HISTORIC AND DESIGN REVIEW COMMISSION

May 18, 2016

HDRC CASE NO:	2016-167
ADDRESS:	1441 SE MILITARY DR
LEGAL DESCRIPTION:	NCB 7657 BLK LOT W IRR 447.39 FT OF P
ZONING:	C3NA H RIO-5
CITY COUNCIL DIST.:	3
DISTRICT:	Mission Historic District
APPLICANT:	Jason Feuge/MDN Architects, Inc
OWNER:	Security Service Federal Credit Union
TYPE OF WORK:	New Construction
REQUEST:

The applicant is requesting conceptual approval to construct a new commercial structure at 1441 SE Military Drive that will include drive through teller lanes, landscaping, surface parking and exterior lighting.

FLOOR PLAN

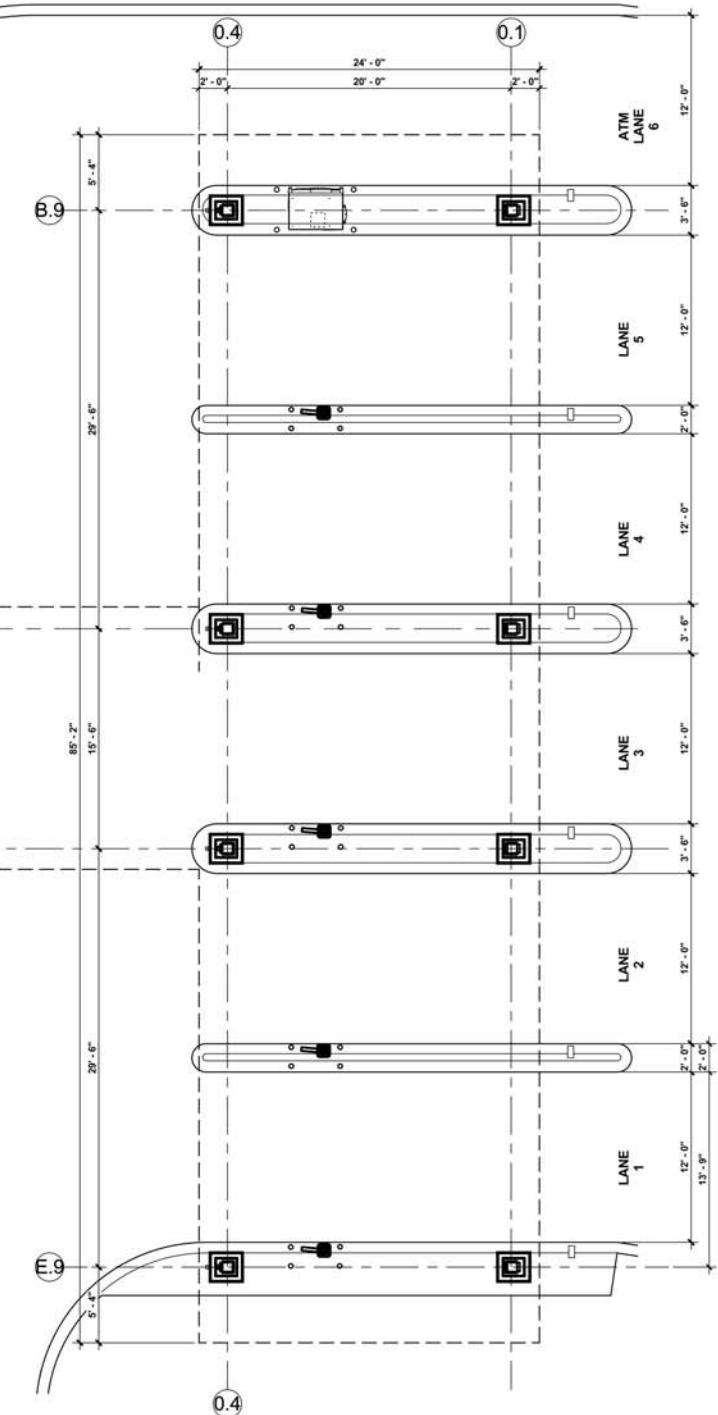
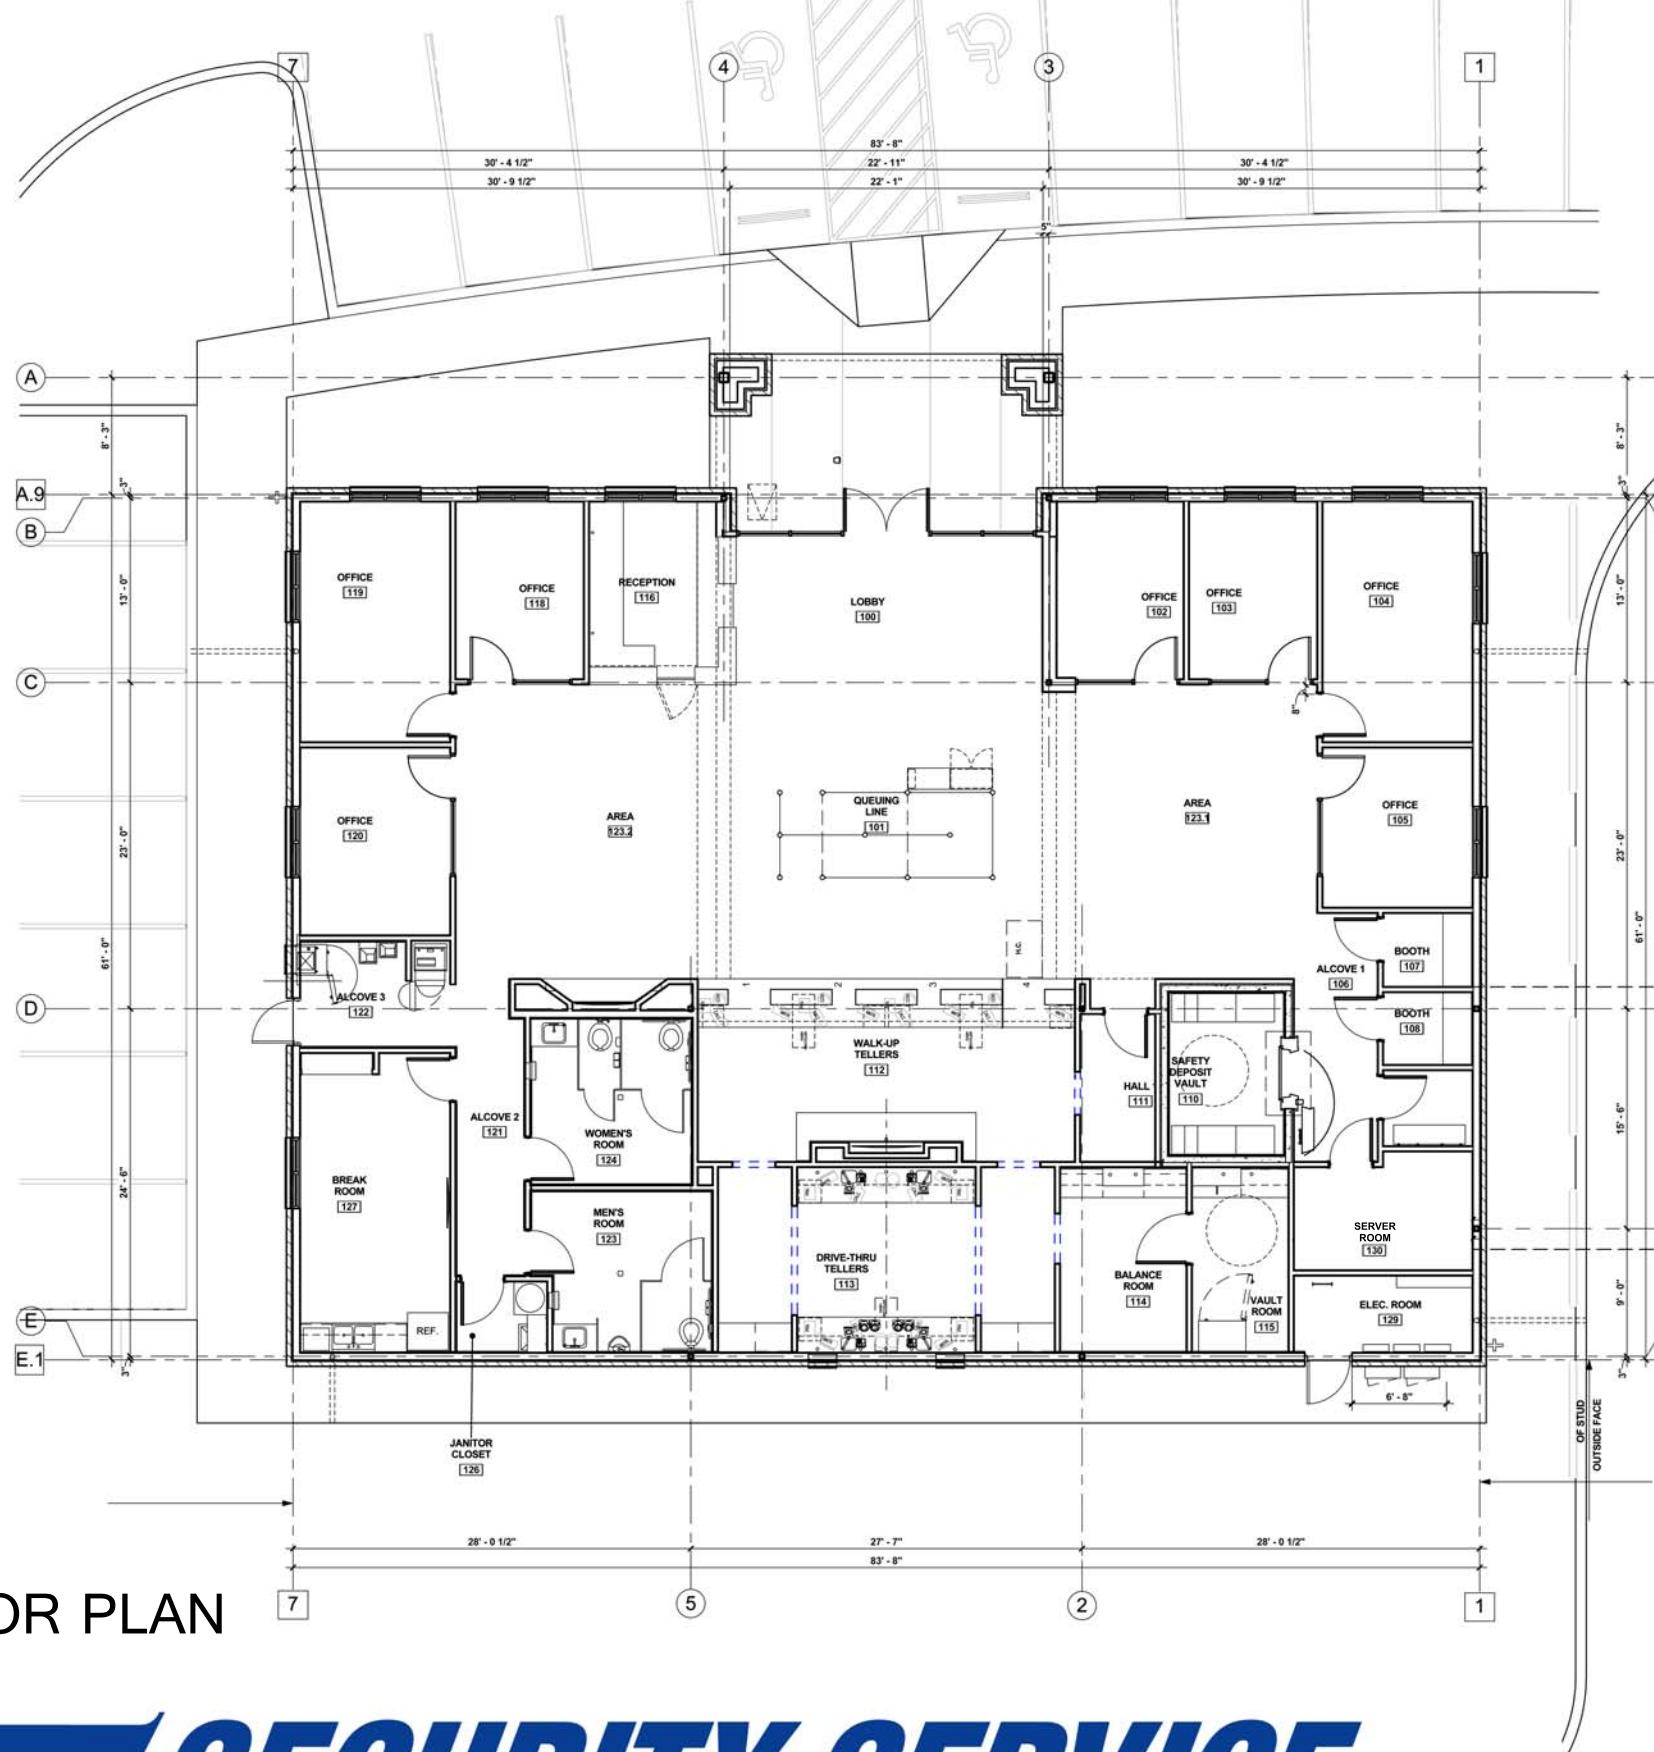
- o. According to the UDC Section 35-674(e)(2), windows help provide a human scale and should be recessed at least two (2) inches within solid walls, windows should relate in design and scale to the spaces behind them and that windows shall be used in hierarchy to articulate important places on the facade and grouped to establish rhythms. While the applicant has arranged windows to establish a rhythm, the applicant has not provided information to staff regarding window materials. Additionally, the applicant should provide a detailed wall section to staff noting that each window will be inset at least two (2) inches within exterior walls.

5. That the applicant provide bicycle parking on site as noted in finding k.
6. That the applicant provide information regarding window materials and a detailed wall section noting that all windows have been inset in walls at least two (2) inches as noted in finding o.

NORTH VIEW

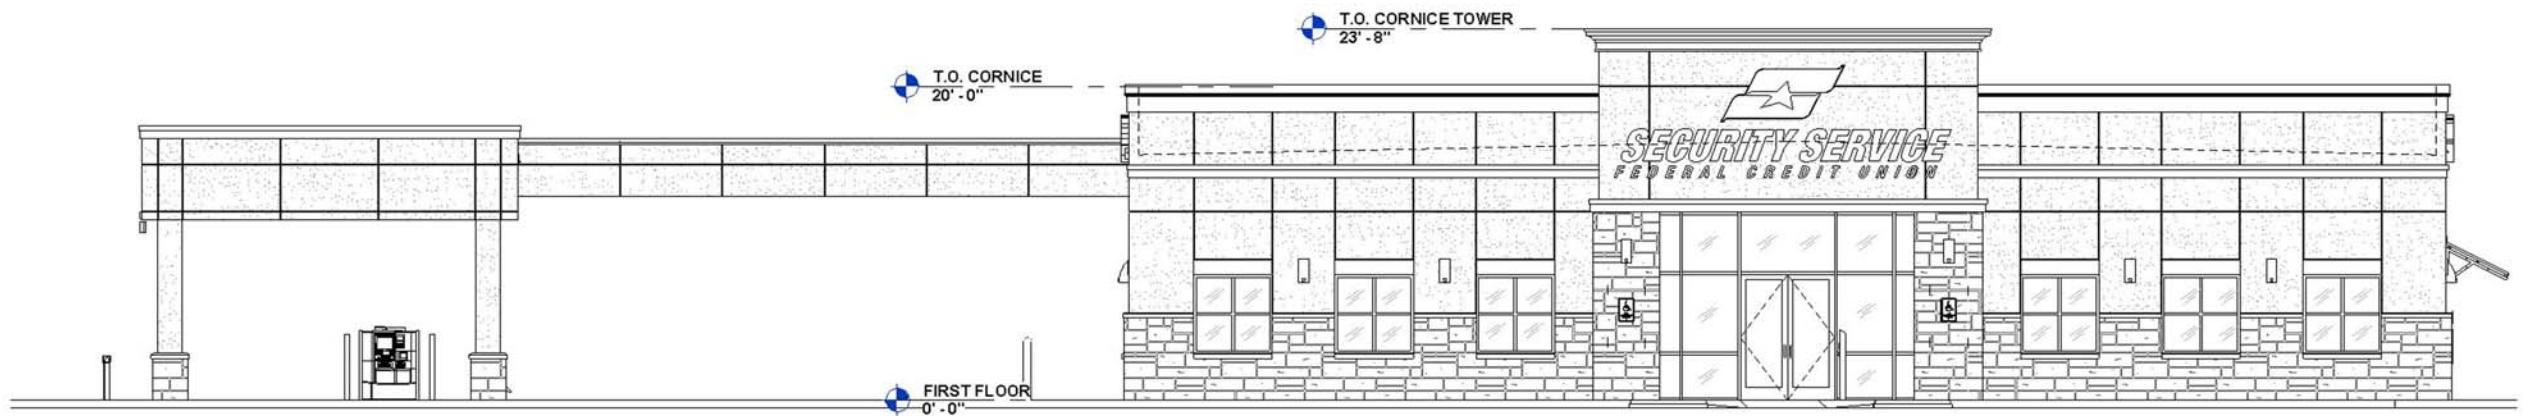
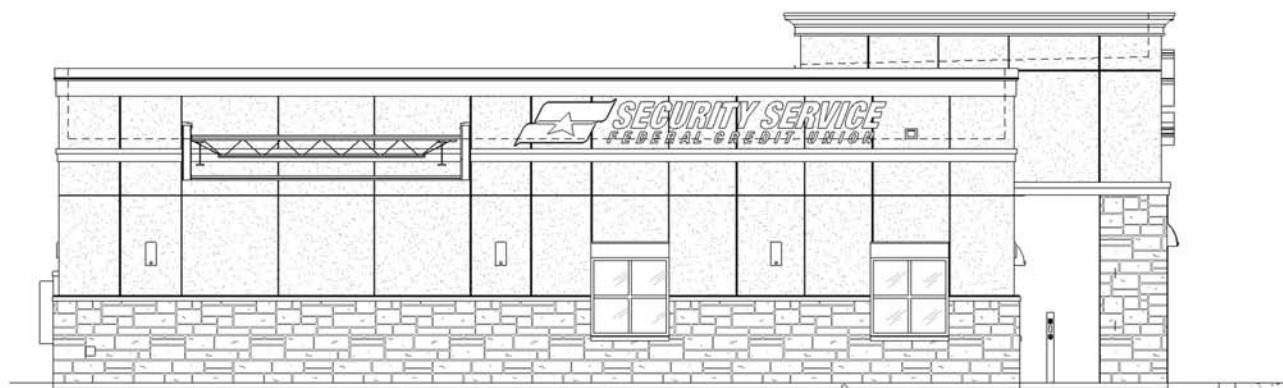
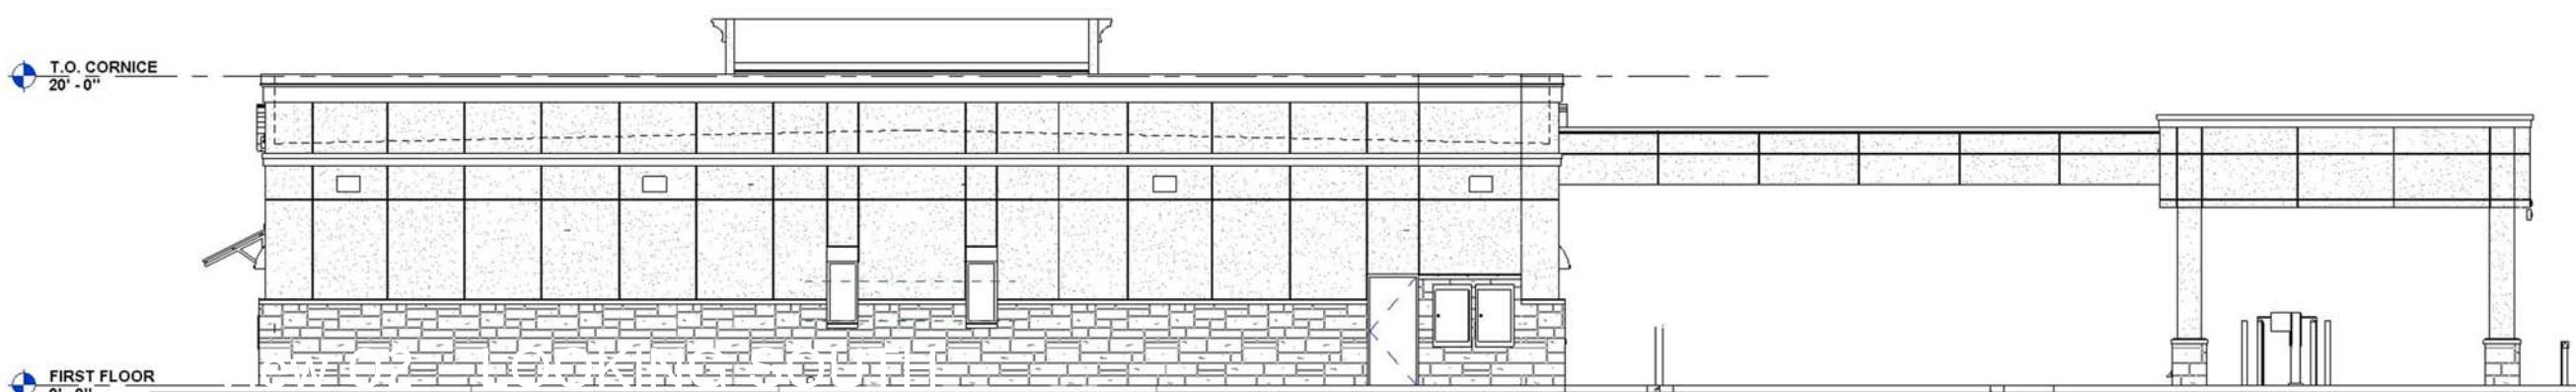
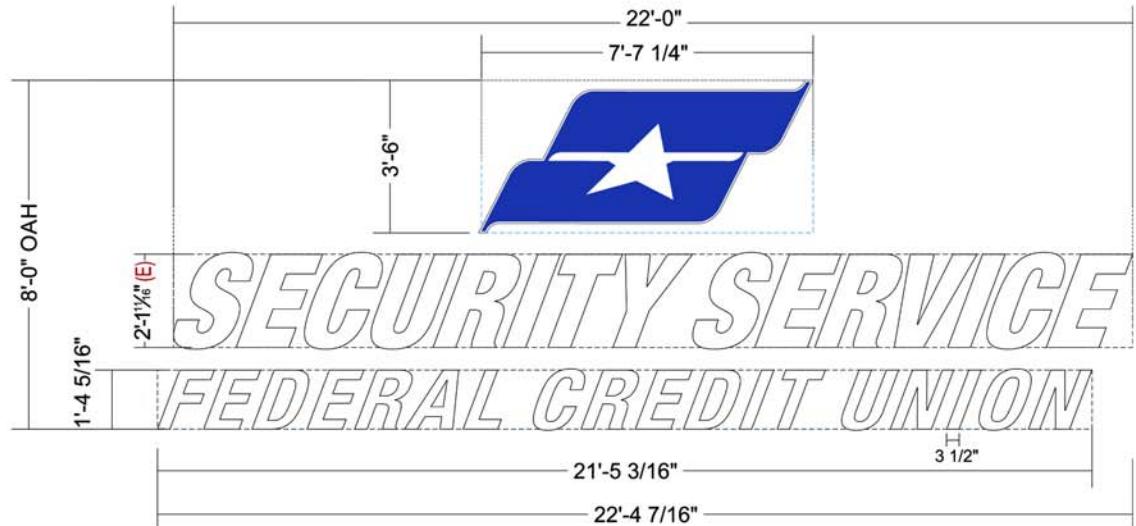
mechanical or service equipment nor how it will be screened. This applicant should provide this information to staff prior to receiving a final approval.

3. That the applicant coordinate with Transportation and Capital Improvements as noted in finding g.
4. That the applicant provide information in regards to the location and screening of all mechanical and service equipment as noted in finding j.
